HISTORIC AND DESIGN REVIEW COMMISSION

May 02, 2018

HDRC CASE NO: 2018-156
ADDRESS: 504 AUSTIN ST
LEGAL DESCRIPTION: NCB 510 BLK 2 LOT A-2
ZONING: D, HS
CITY COUNCIL DIST.: 2
LANDMARK: La Fama Bakery, Alt House, Rear House
APPLICANT: Chris Gill/CGRE LTC CO
OWNER: Chris Gill/CGRE LTC CO
TYPE OF WORK: Construction of a rear addition, construction of a rooftop addition, painting and Historic Tax Certification
APPLICATION RECEIVED: April 02, 2018
60-DAY REVIEW: June 01, 2018
REQUEST:

STOREFRONT SYSTEM CURRENTLY BEING INSTALLED - PROFILE AND MATERIALS ARE INCONSISTENT

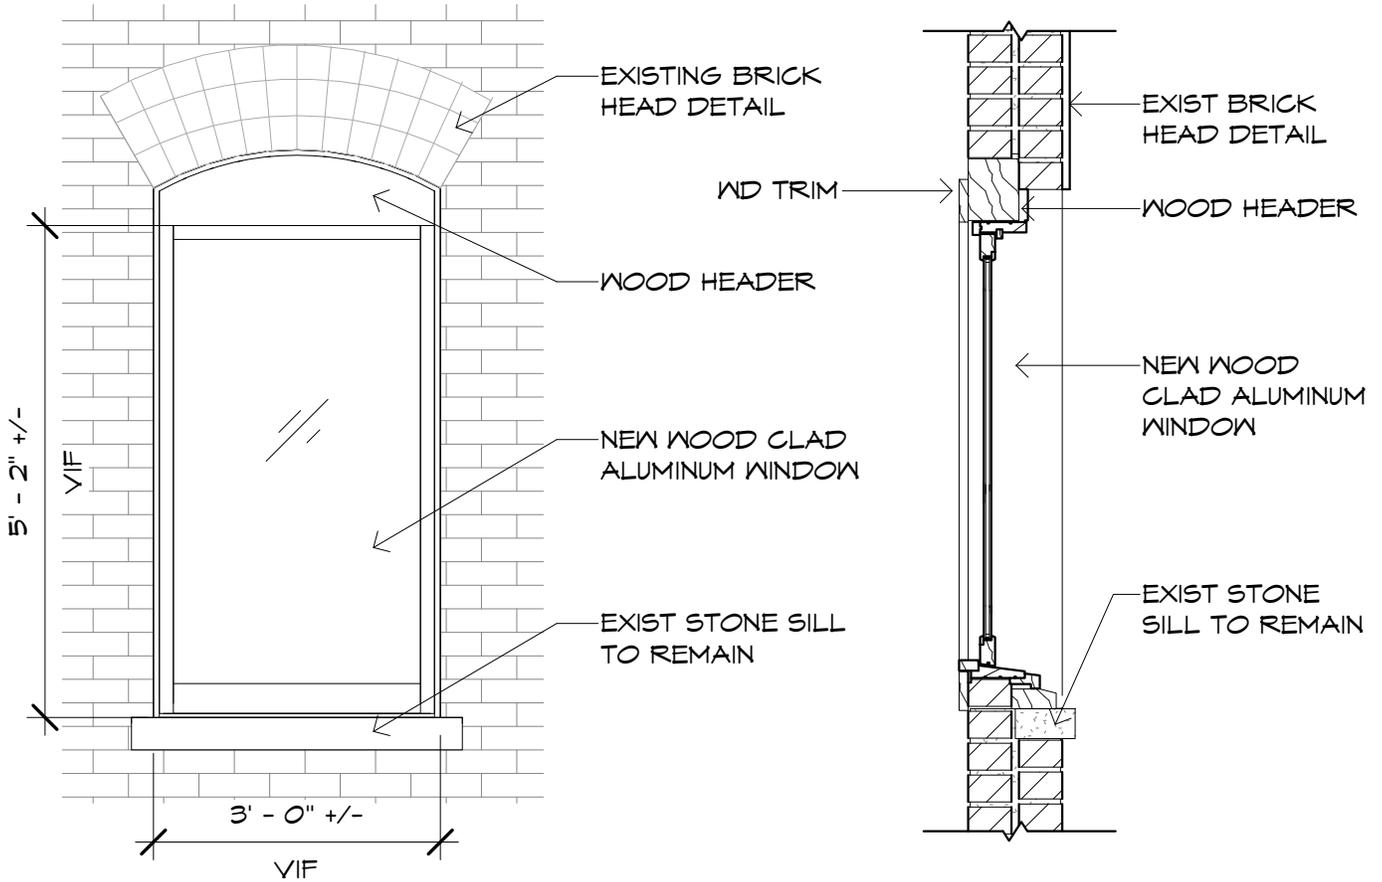
Staff performed a site visit on April 13, 2018, and found scopes of work including roofing, storefront system installation, roof decking installation and exterior modifications being performed inconsistently with previous approvals. The profile and materials of both the storefront system and roofing are inconsistent with previous approvals. Additionally, the profile of the proposed roof deck is inconsistent with previous approvals.

- v. That inconsistencies in current scopes of work related to storefront systems, roof decking, exterior modifications and roofing be corrected to match all previous approvals in regards to materials, architectural profiles and details.

5 WINDOW DETAIL
3/4" = 1'-0"

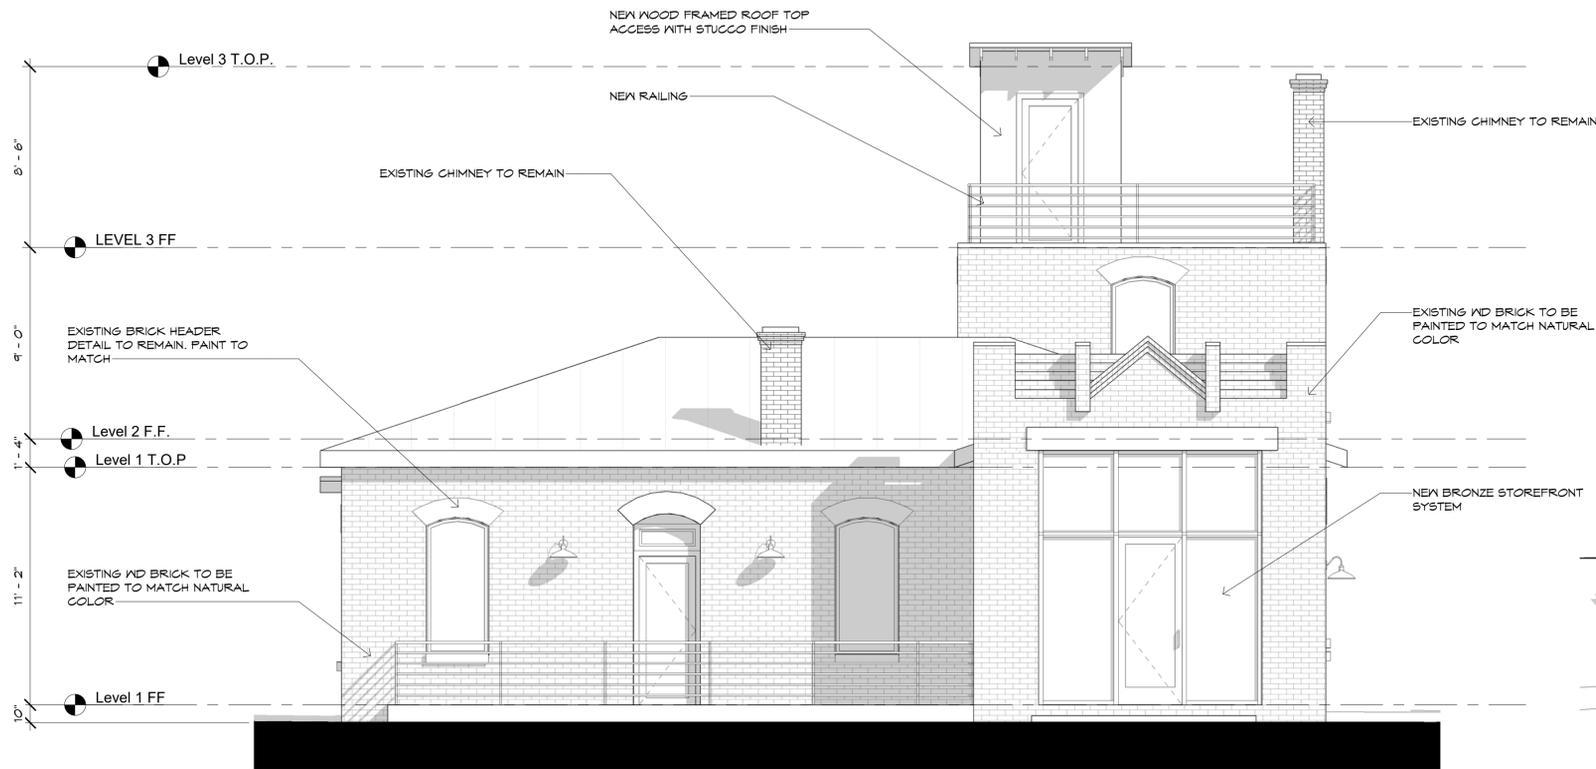
- g. WINDOW MATERIALS – The applicant has noted the installation of aluminum clad wood windows; however, is requesting to amend the previously approved fixed windows for divided lite windows. The historic structure currently features remains of both one over one and two over two wood windows. The applicant has noted matching the one over one window profile. Staff finds this appropriate and consistent with the Guidelines for Exterior Maintenance and Alterations 6.B.iv. as well as the matching of a two over two profile. White manufacturer’s color is not allowed, and color selection must be presented to staff. There should be a minimum of two inches in depth between the front face of the window trim and the front face of the top window sash. This must be accomplished by recessing the window sufficiently within the opening or with the installation of additional window trim to add thickness. Window trim must feature traditional dimensions and an architecturally appropriate sill detail. Window track components must be painted to match the window trim or concealed by a wood window screen set within the opening.

- i. That the applicant submit final window specifications to staff for approval. White manufacturer's color is not allowed, and color selection must be presented to staff. There should be a minimum of two inches in depth between the front face of the window trim and the front face of the top window sash. This must be accomplished by recessing the window sufficiently within the opening or with the installation of additional window trim to add thickness. Window trim must feature traditional dimensions and an architecturally appropriate sill detail. Window track components must be painted to match the window trim or concealed by a wood window screen set within the opening.
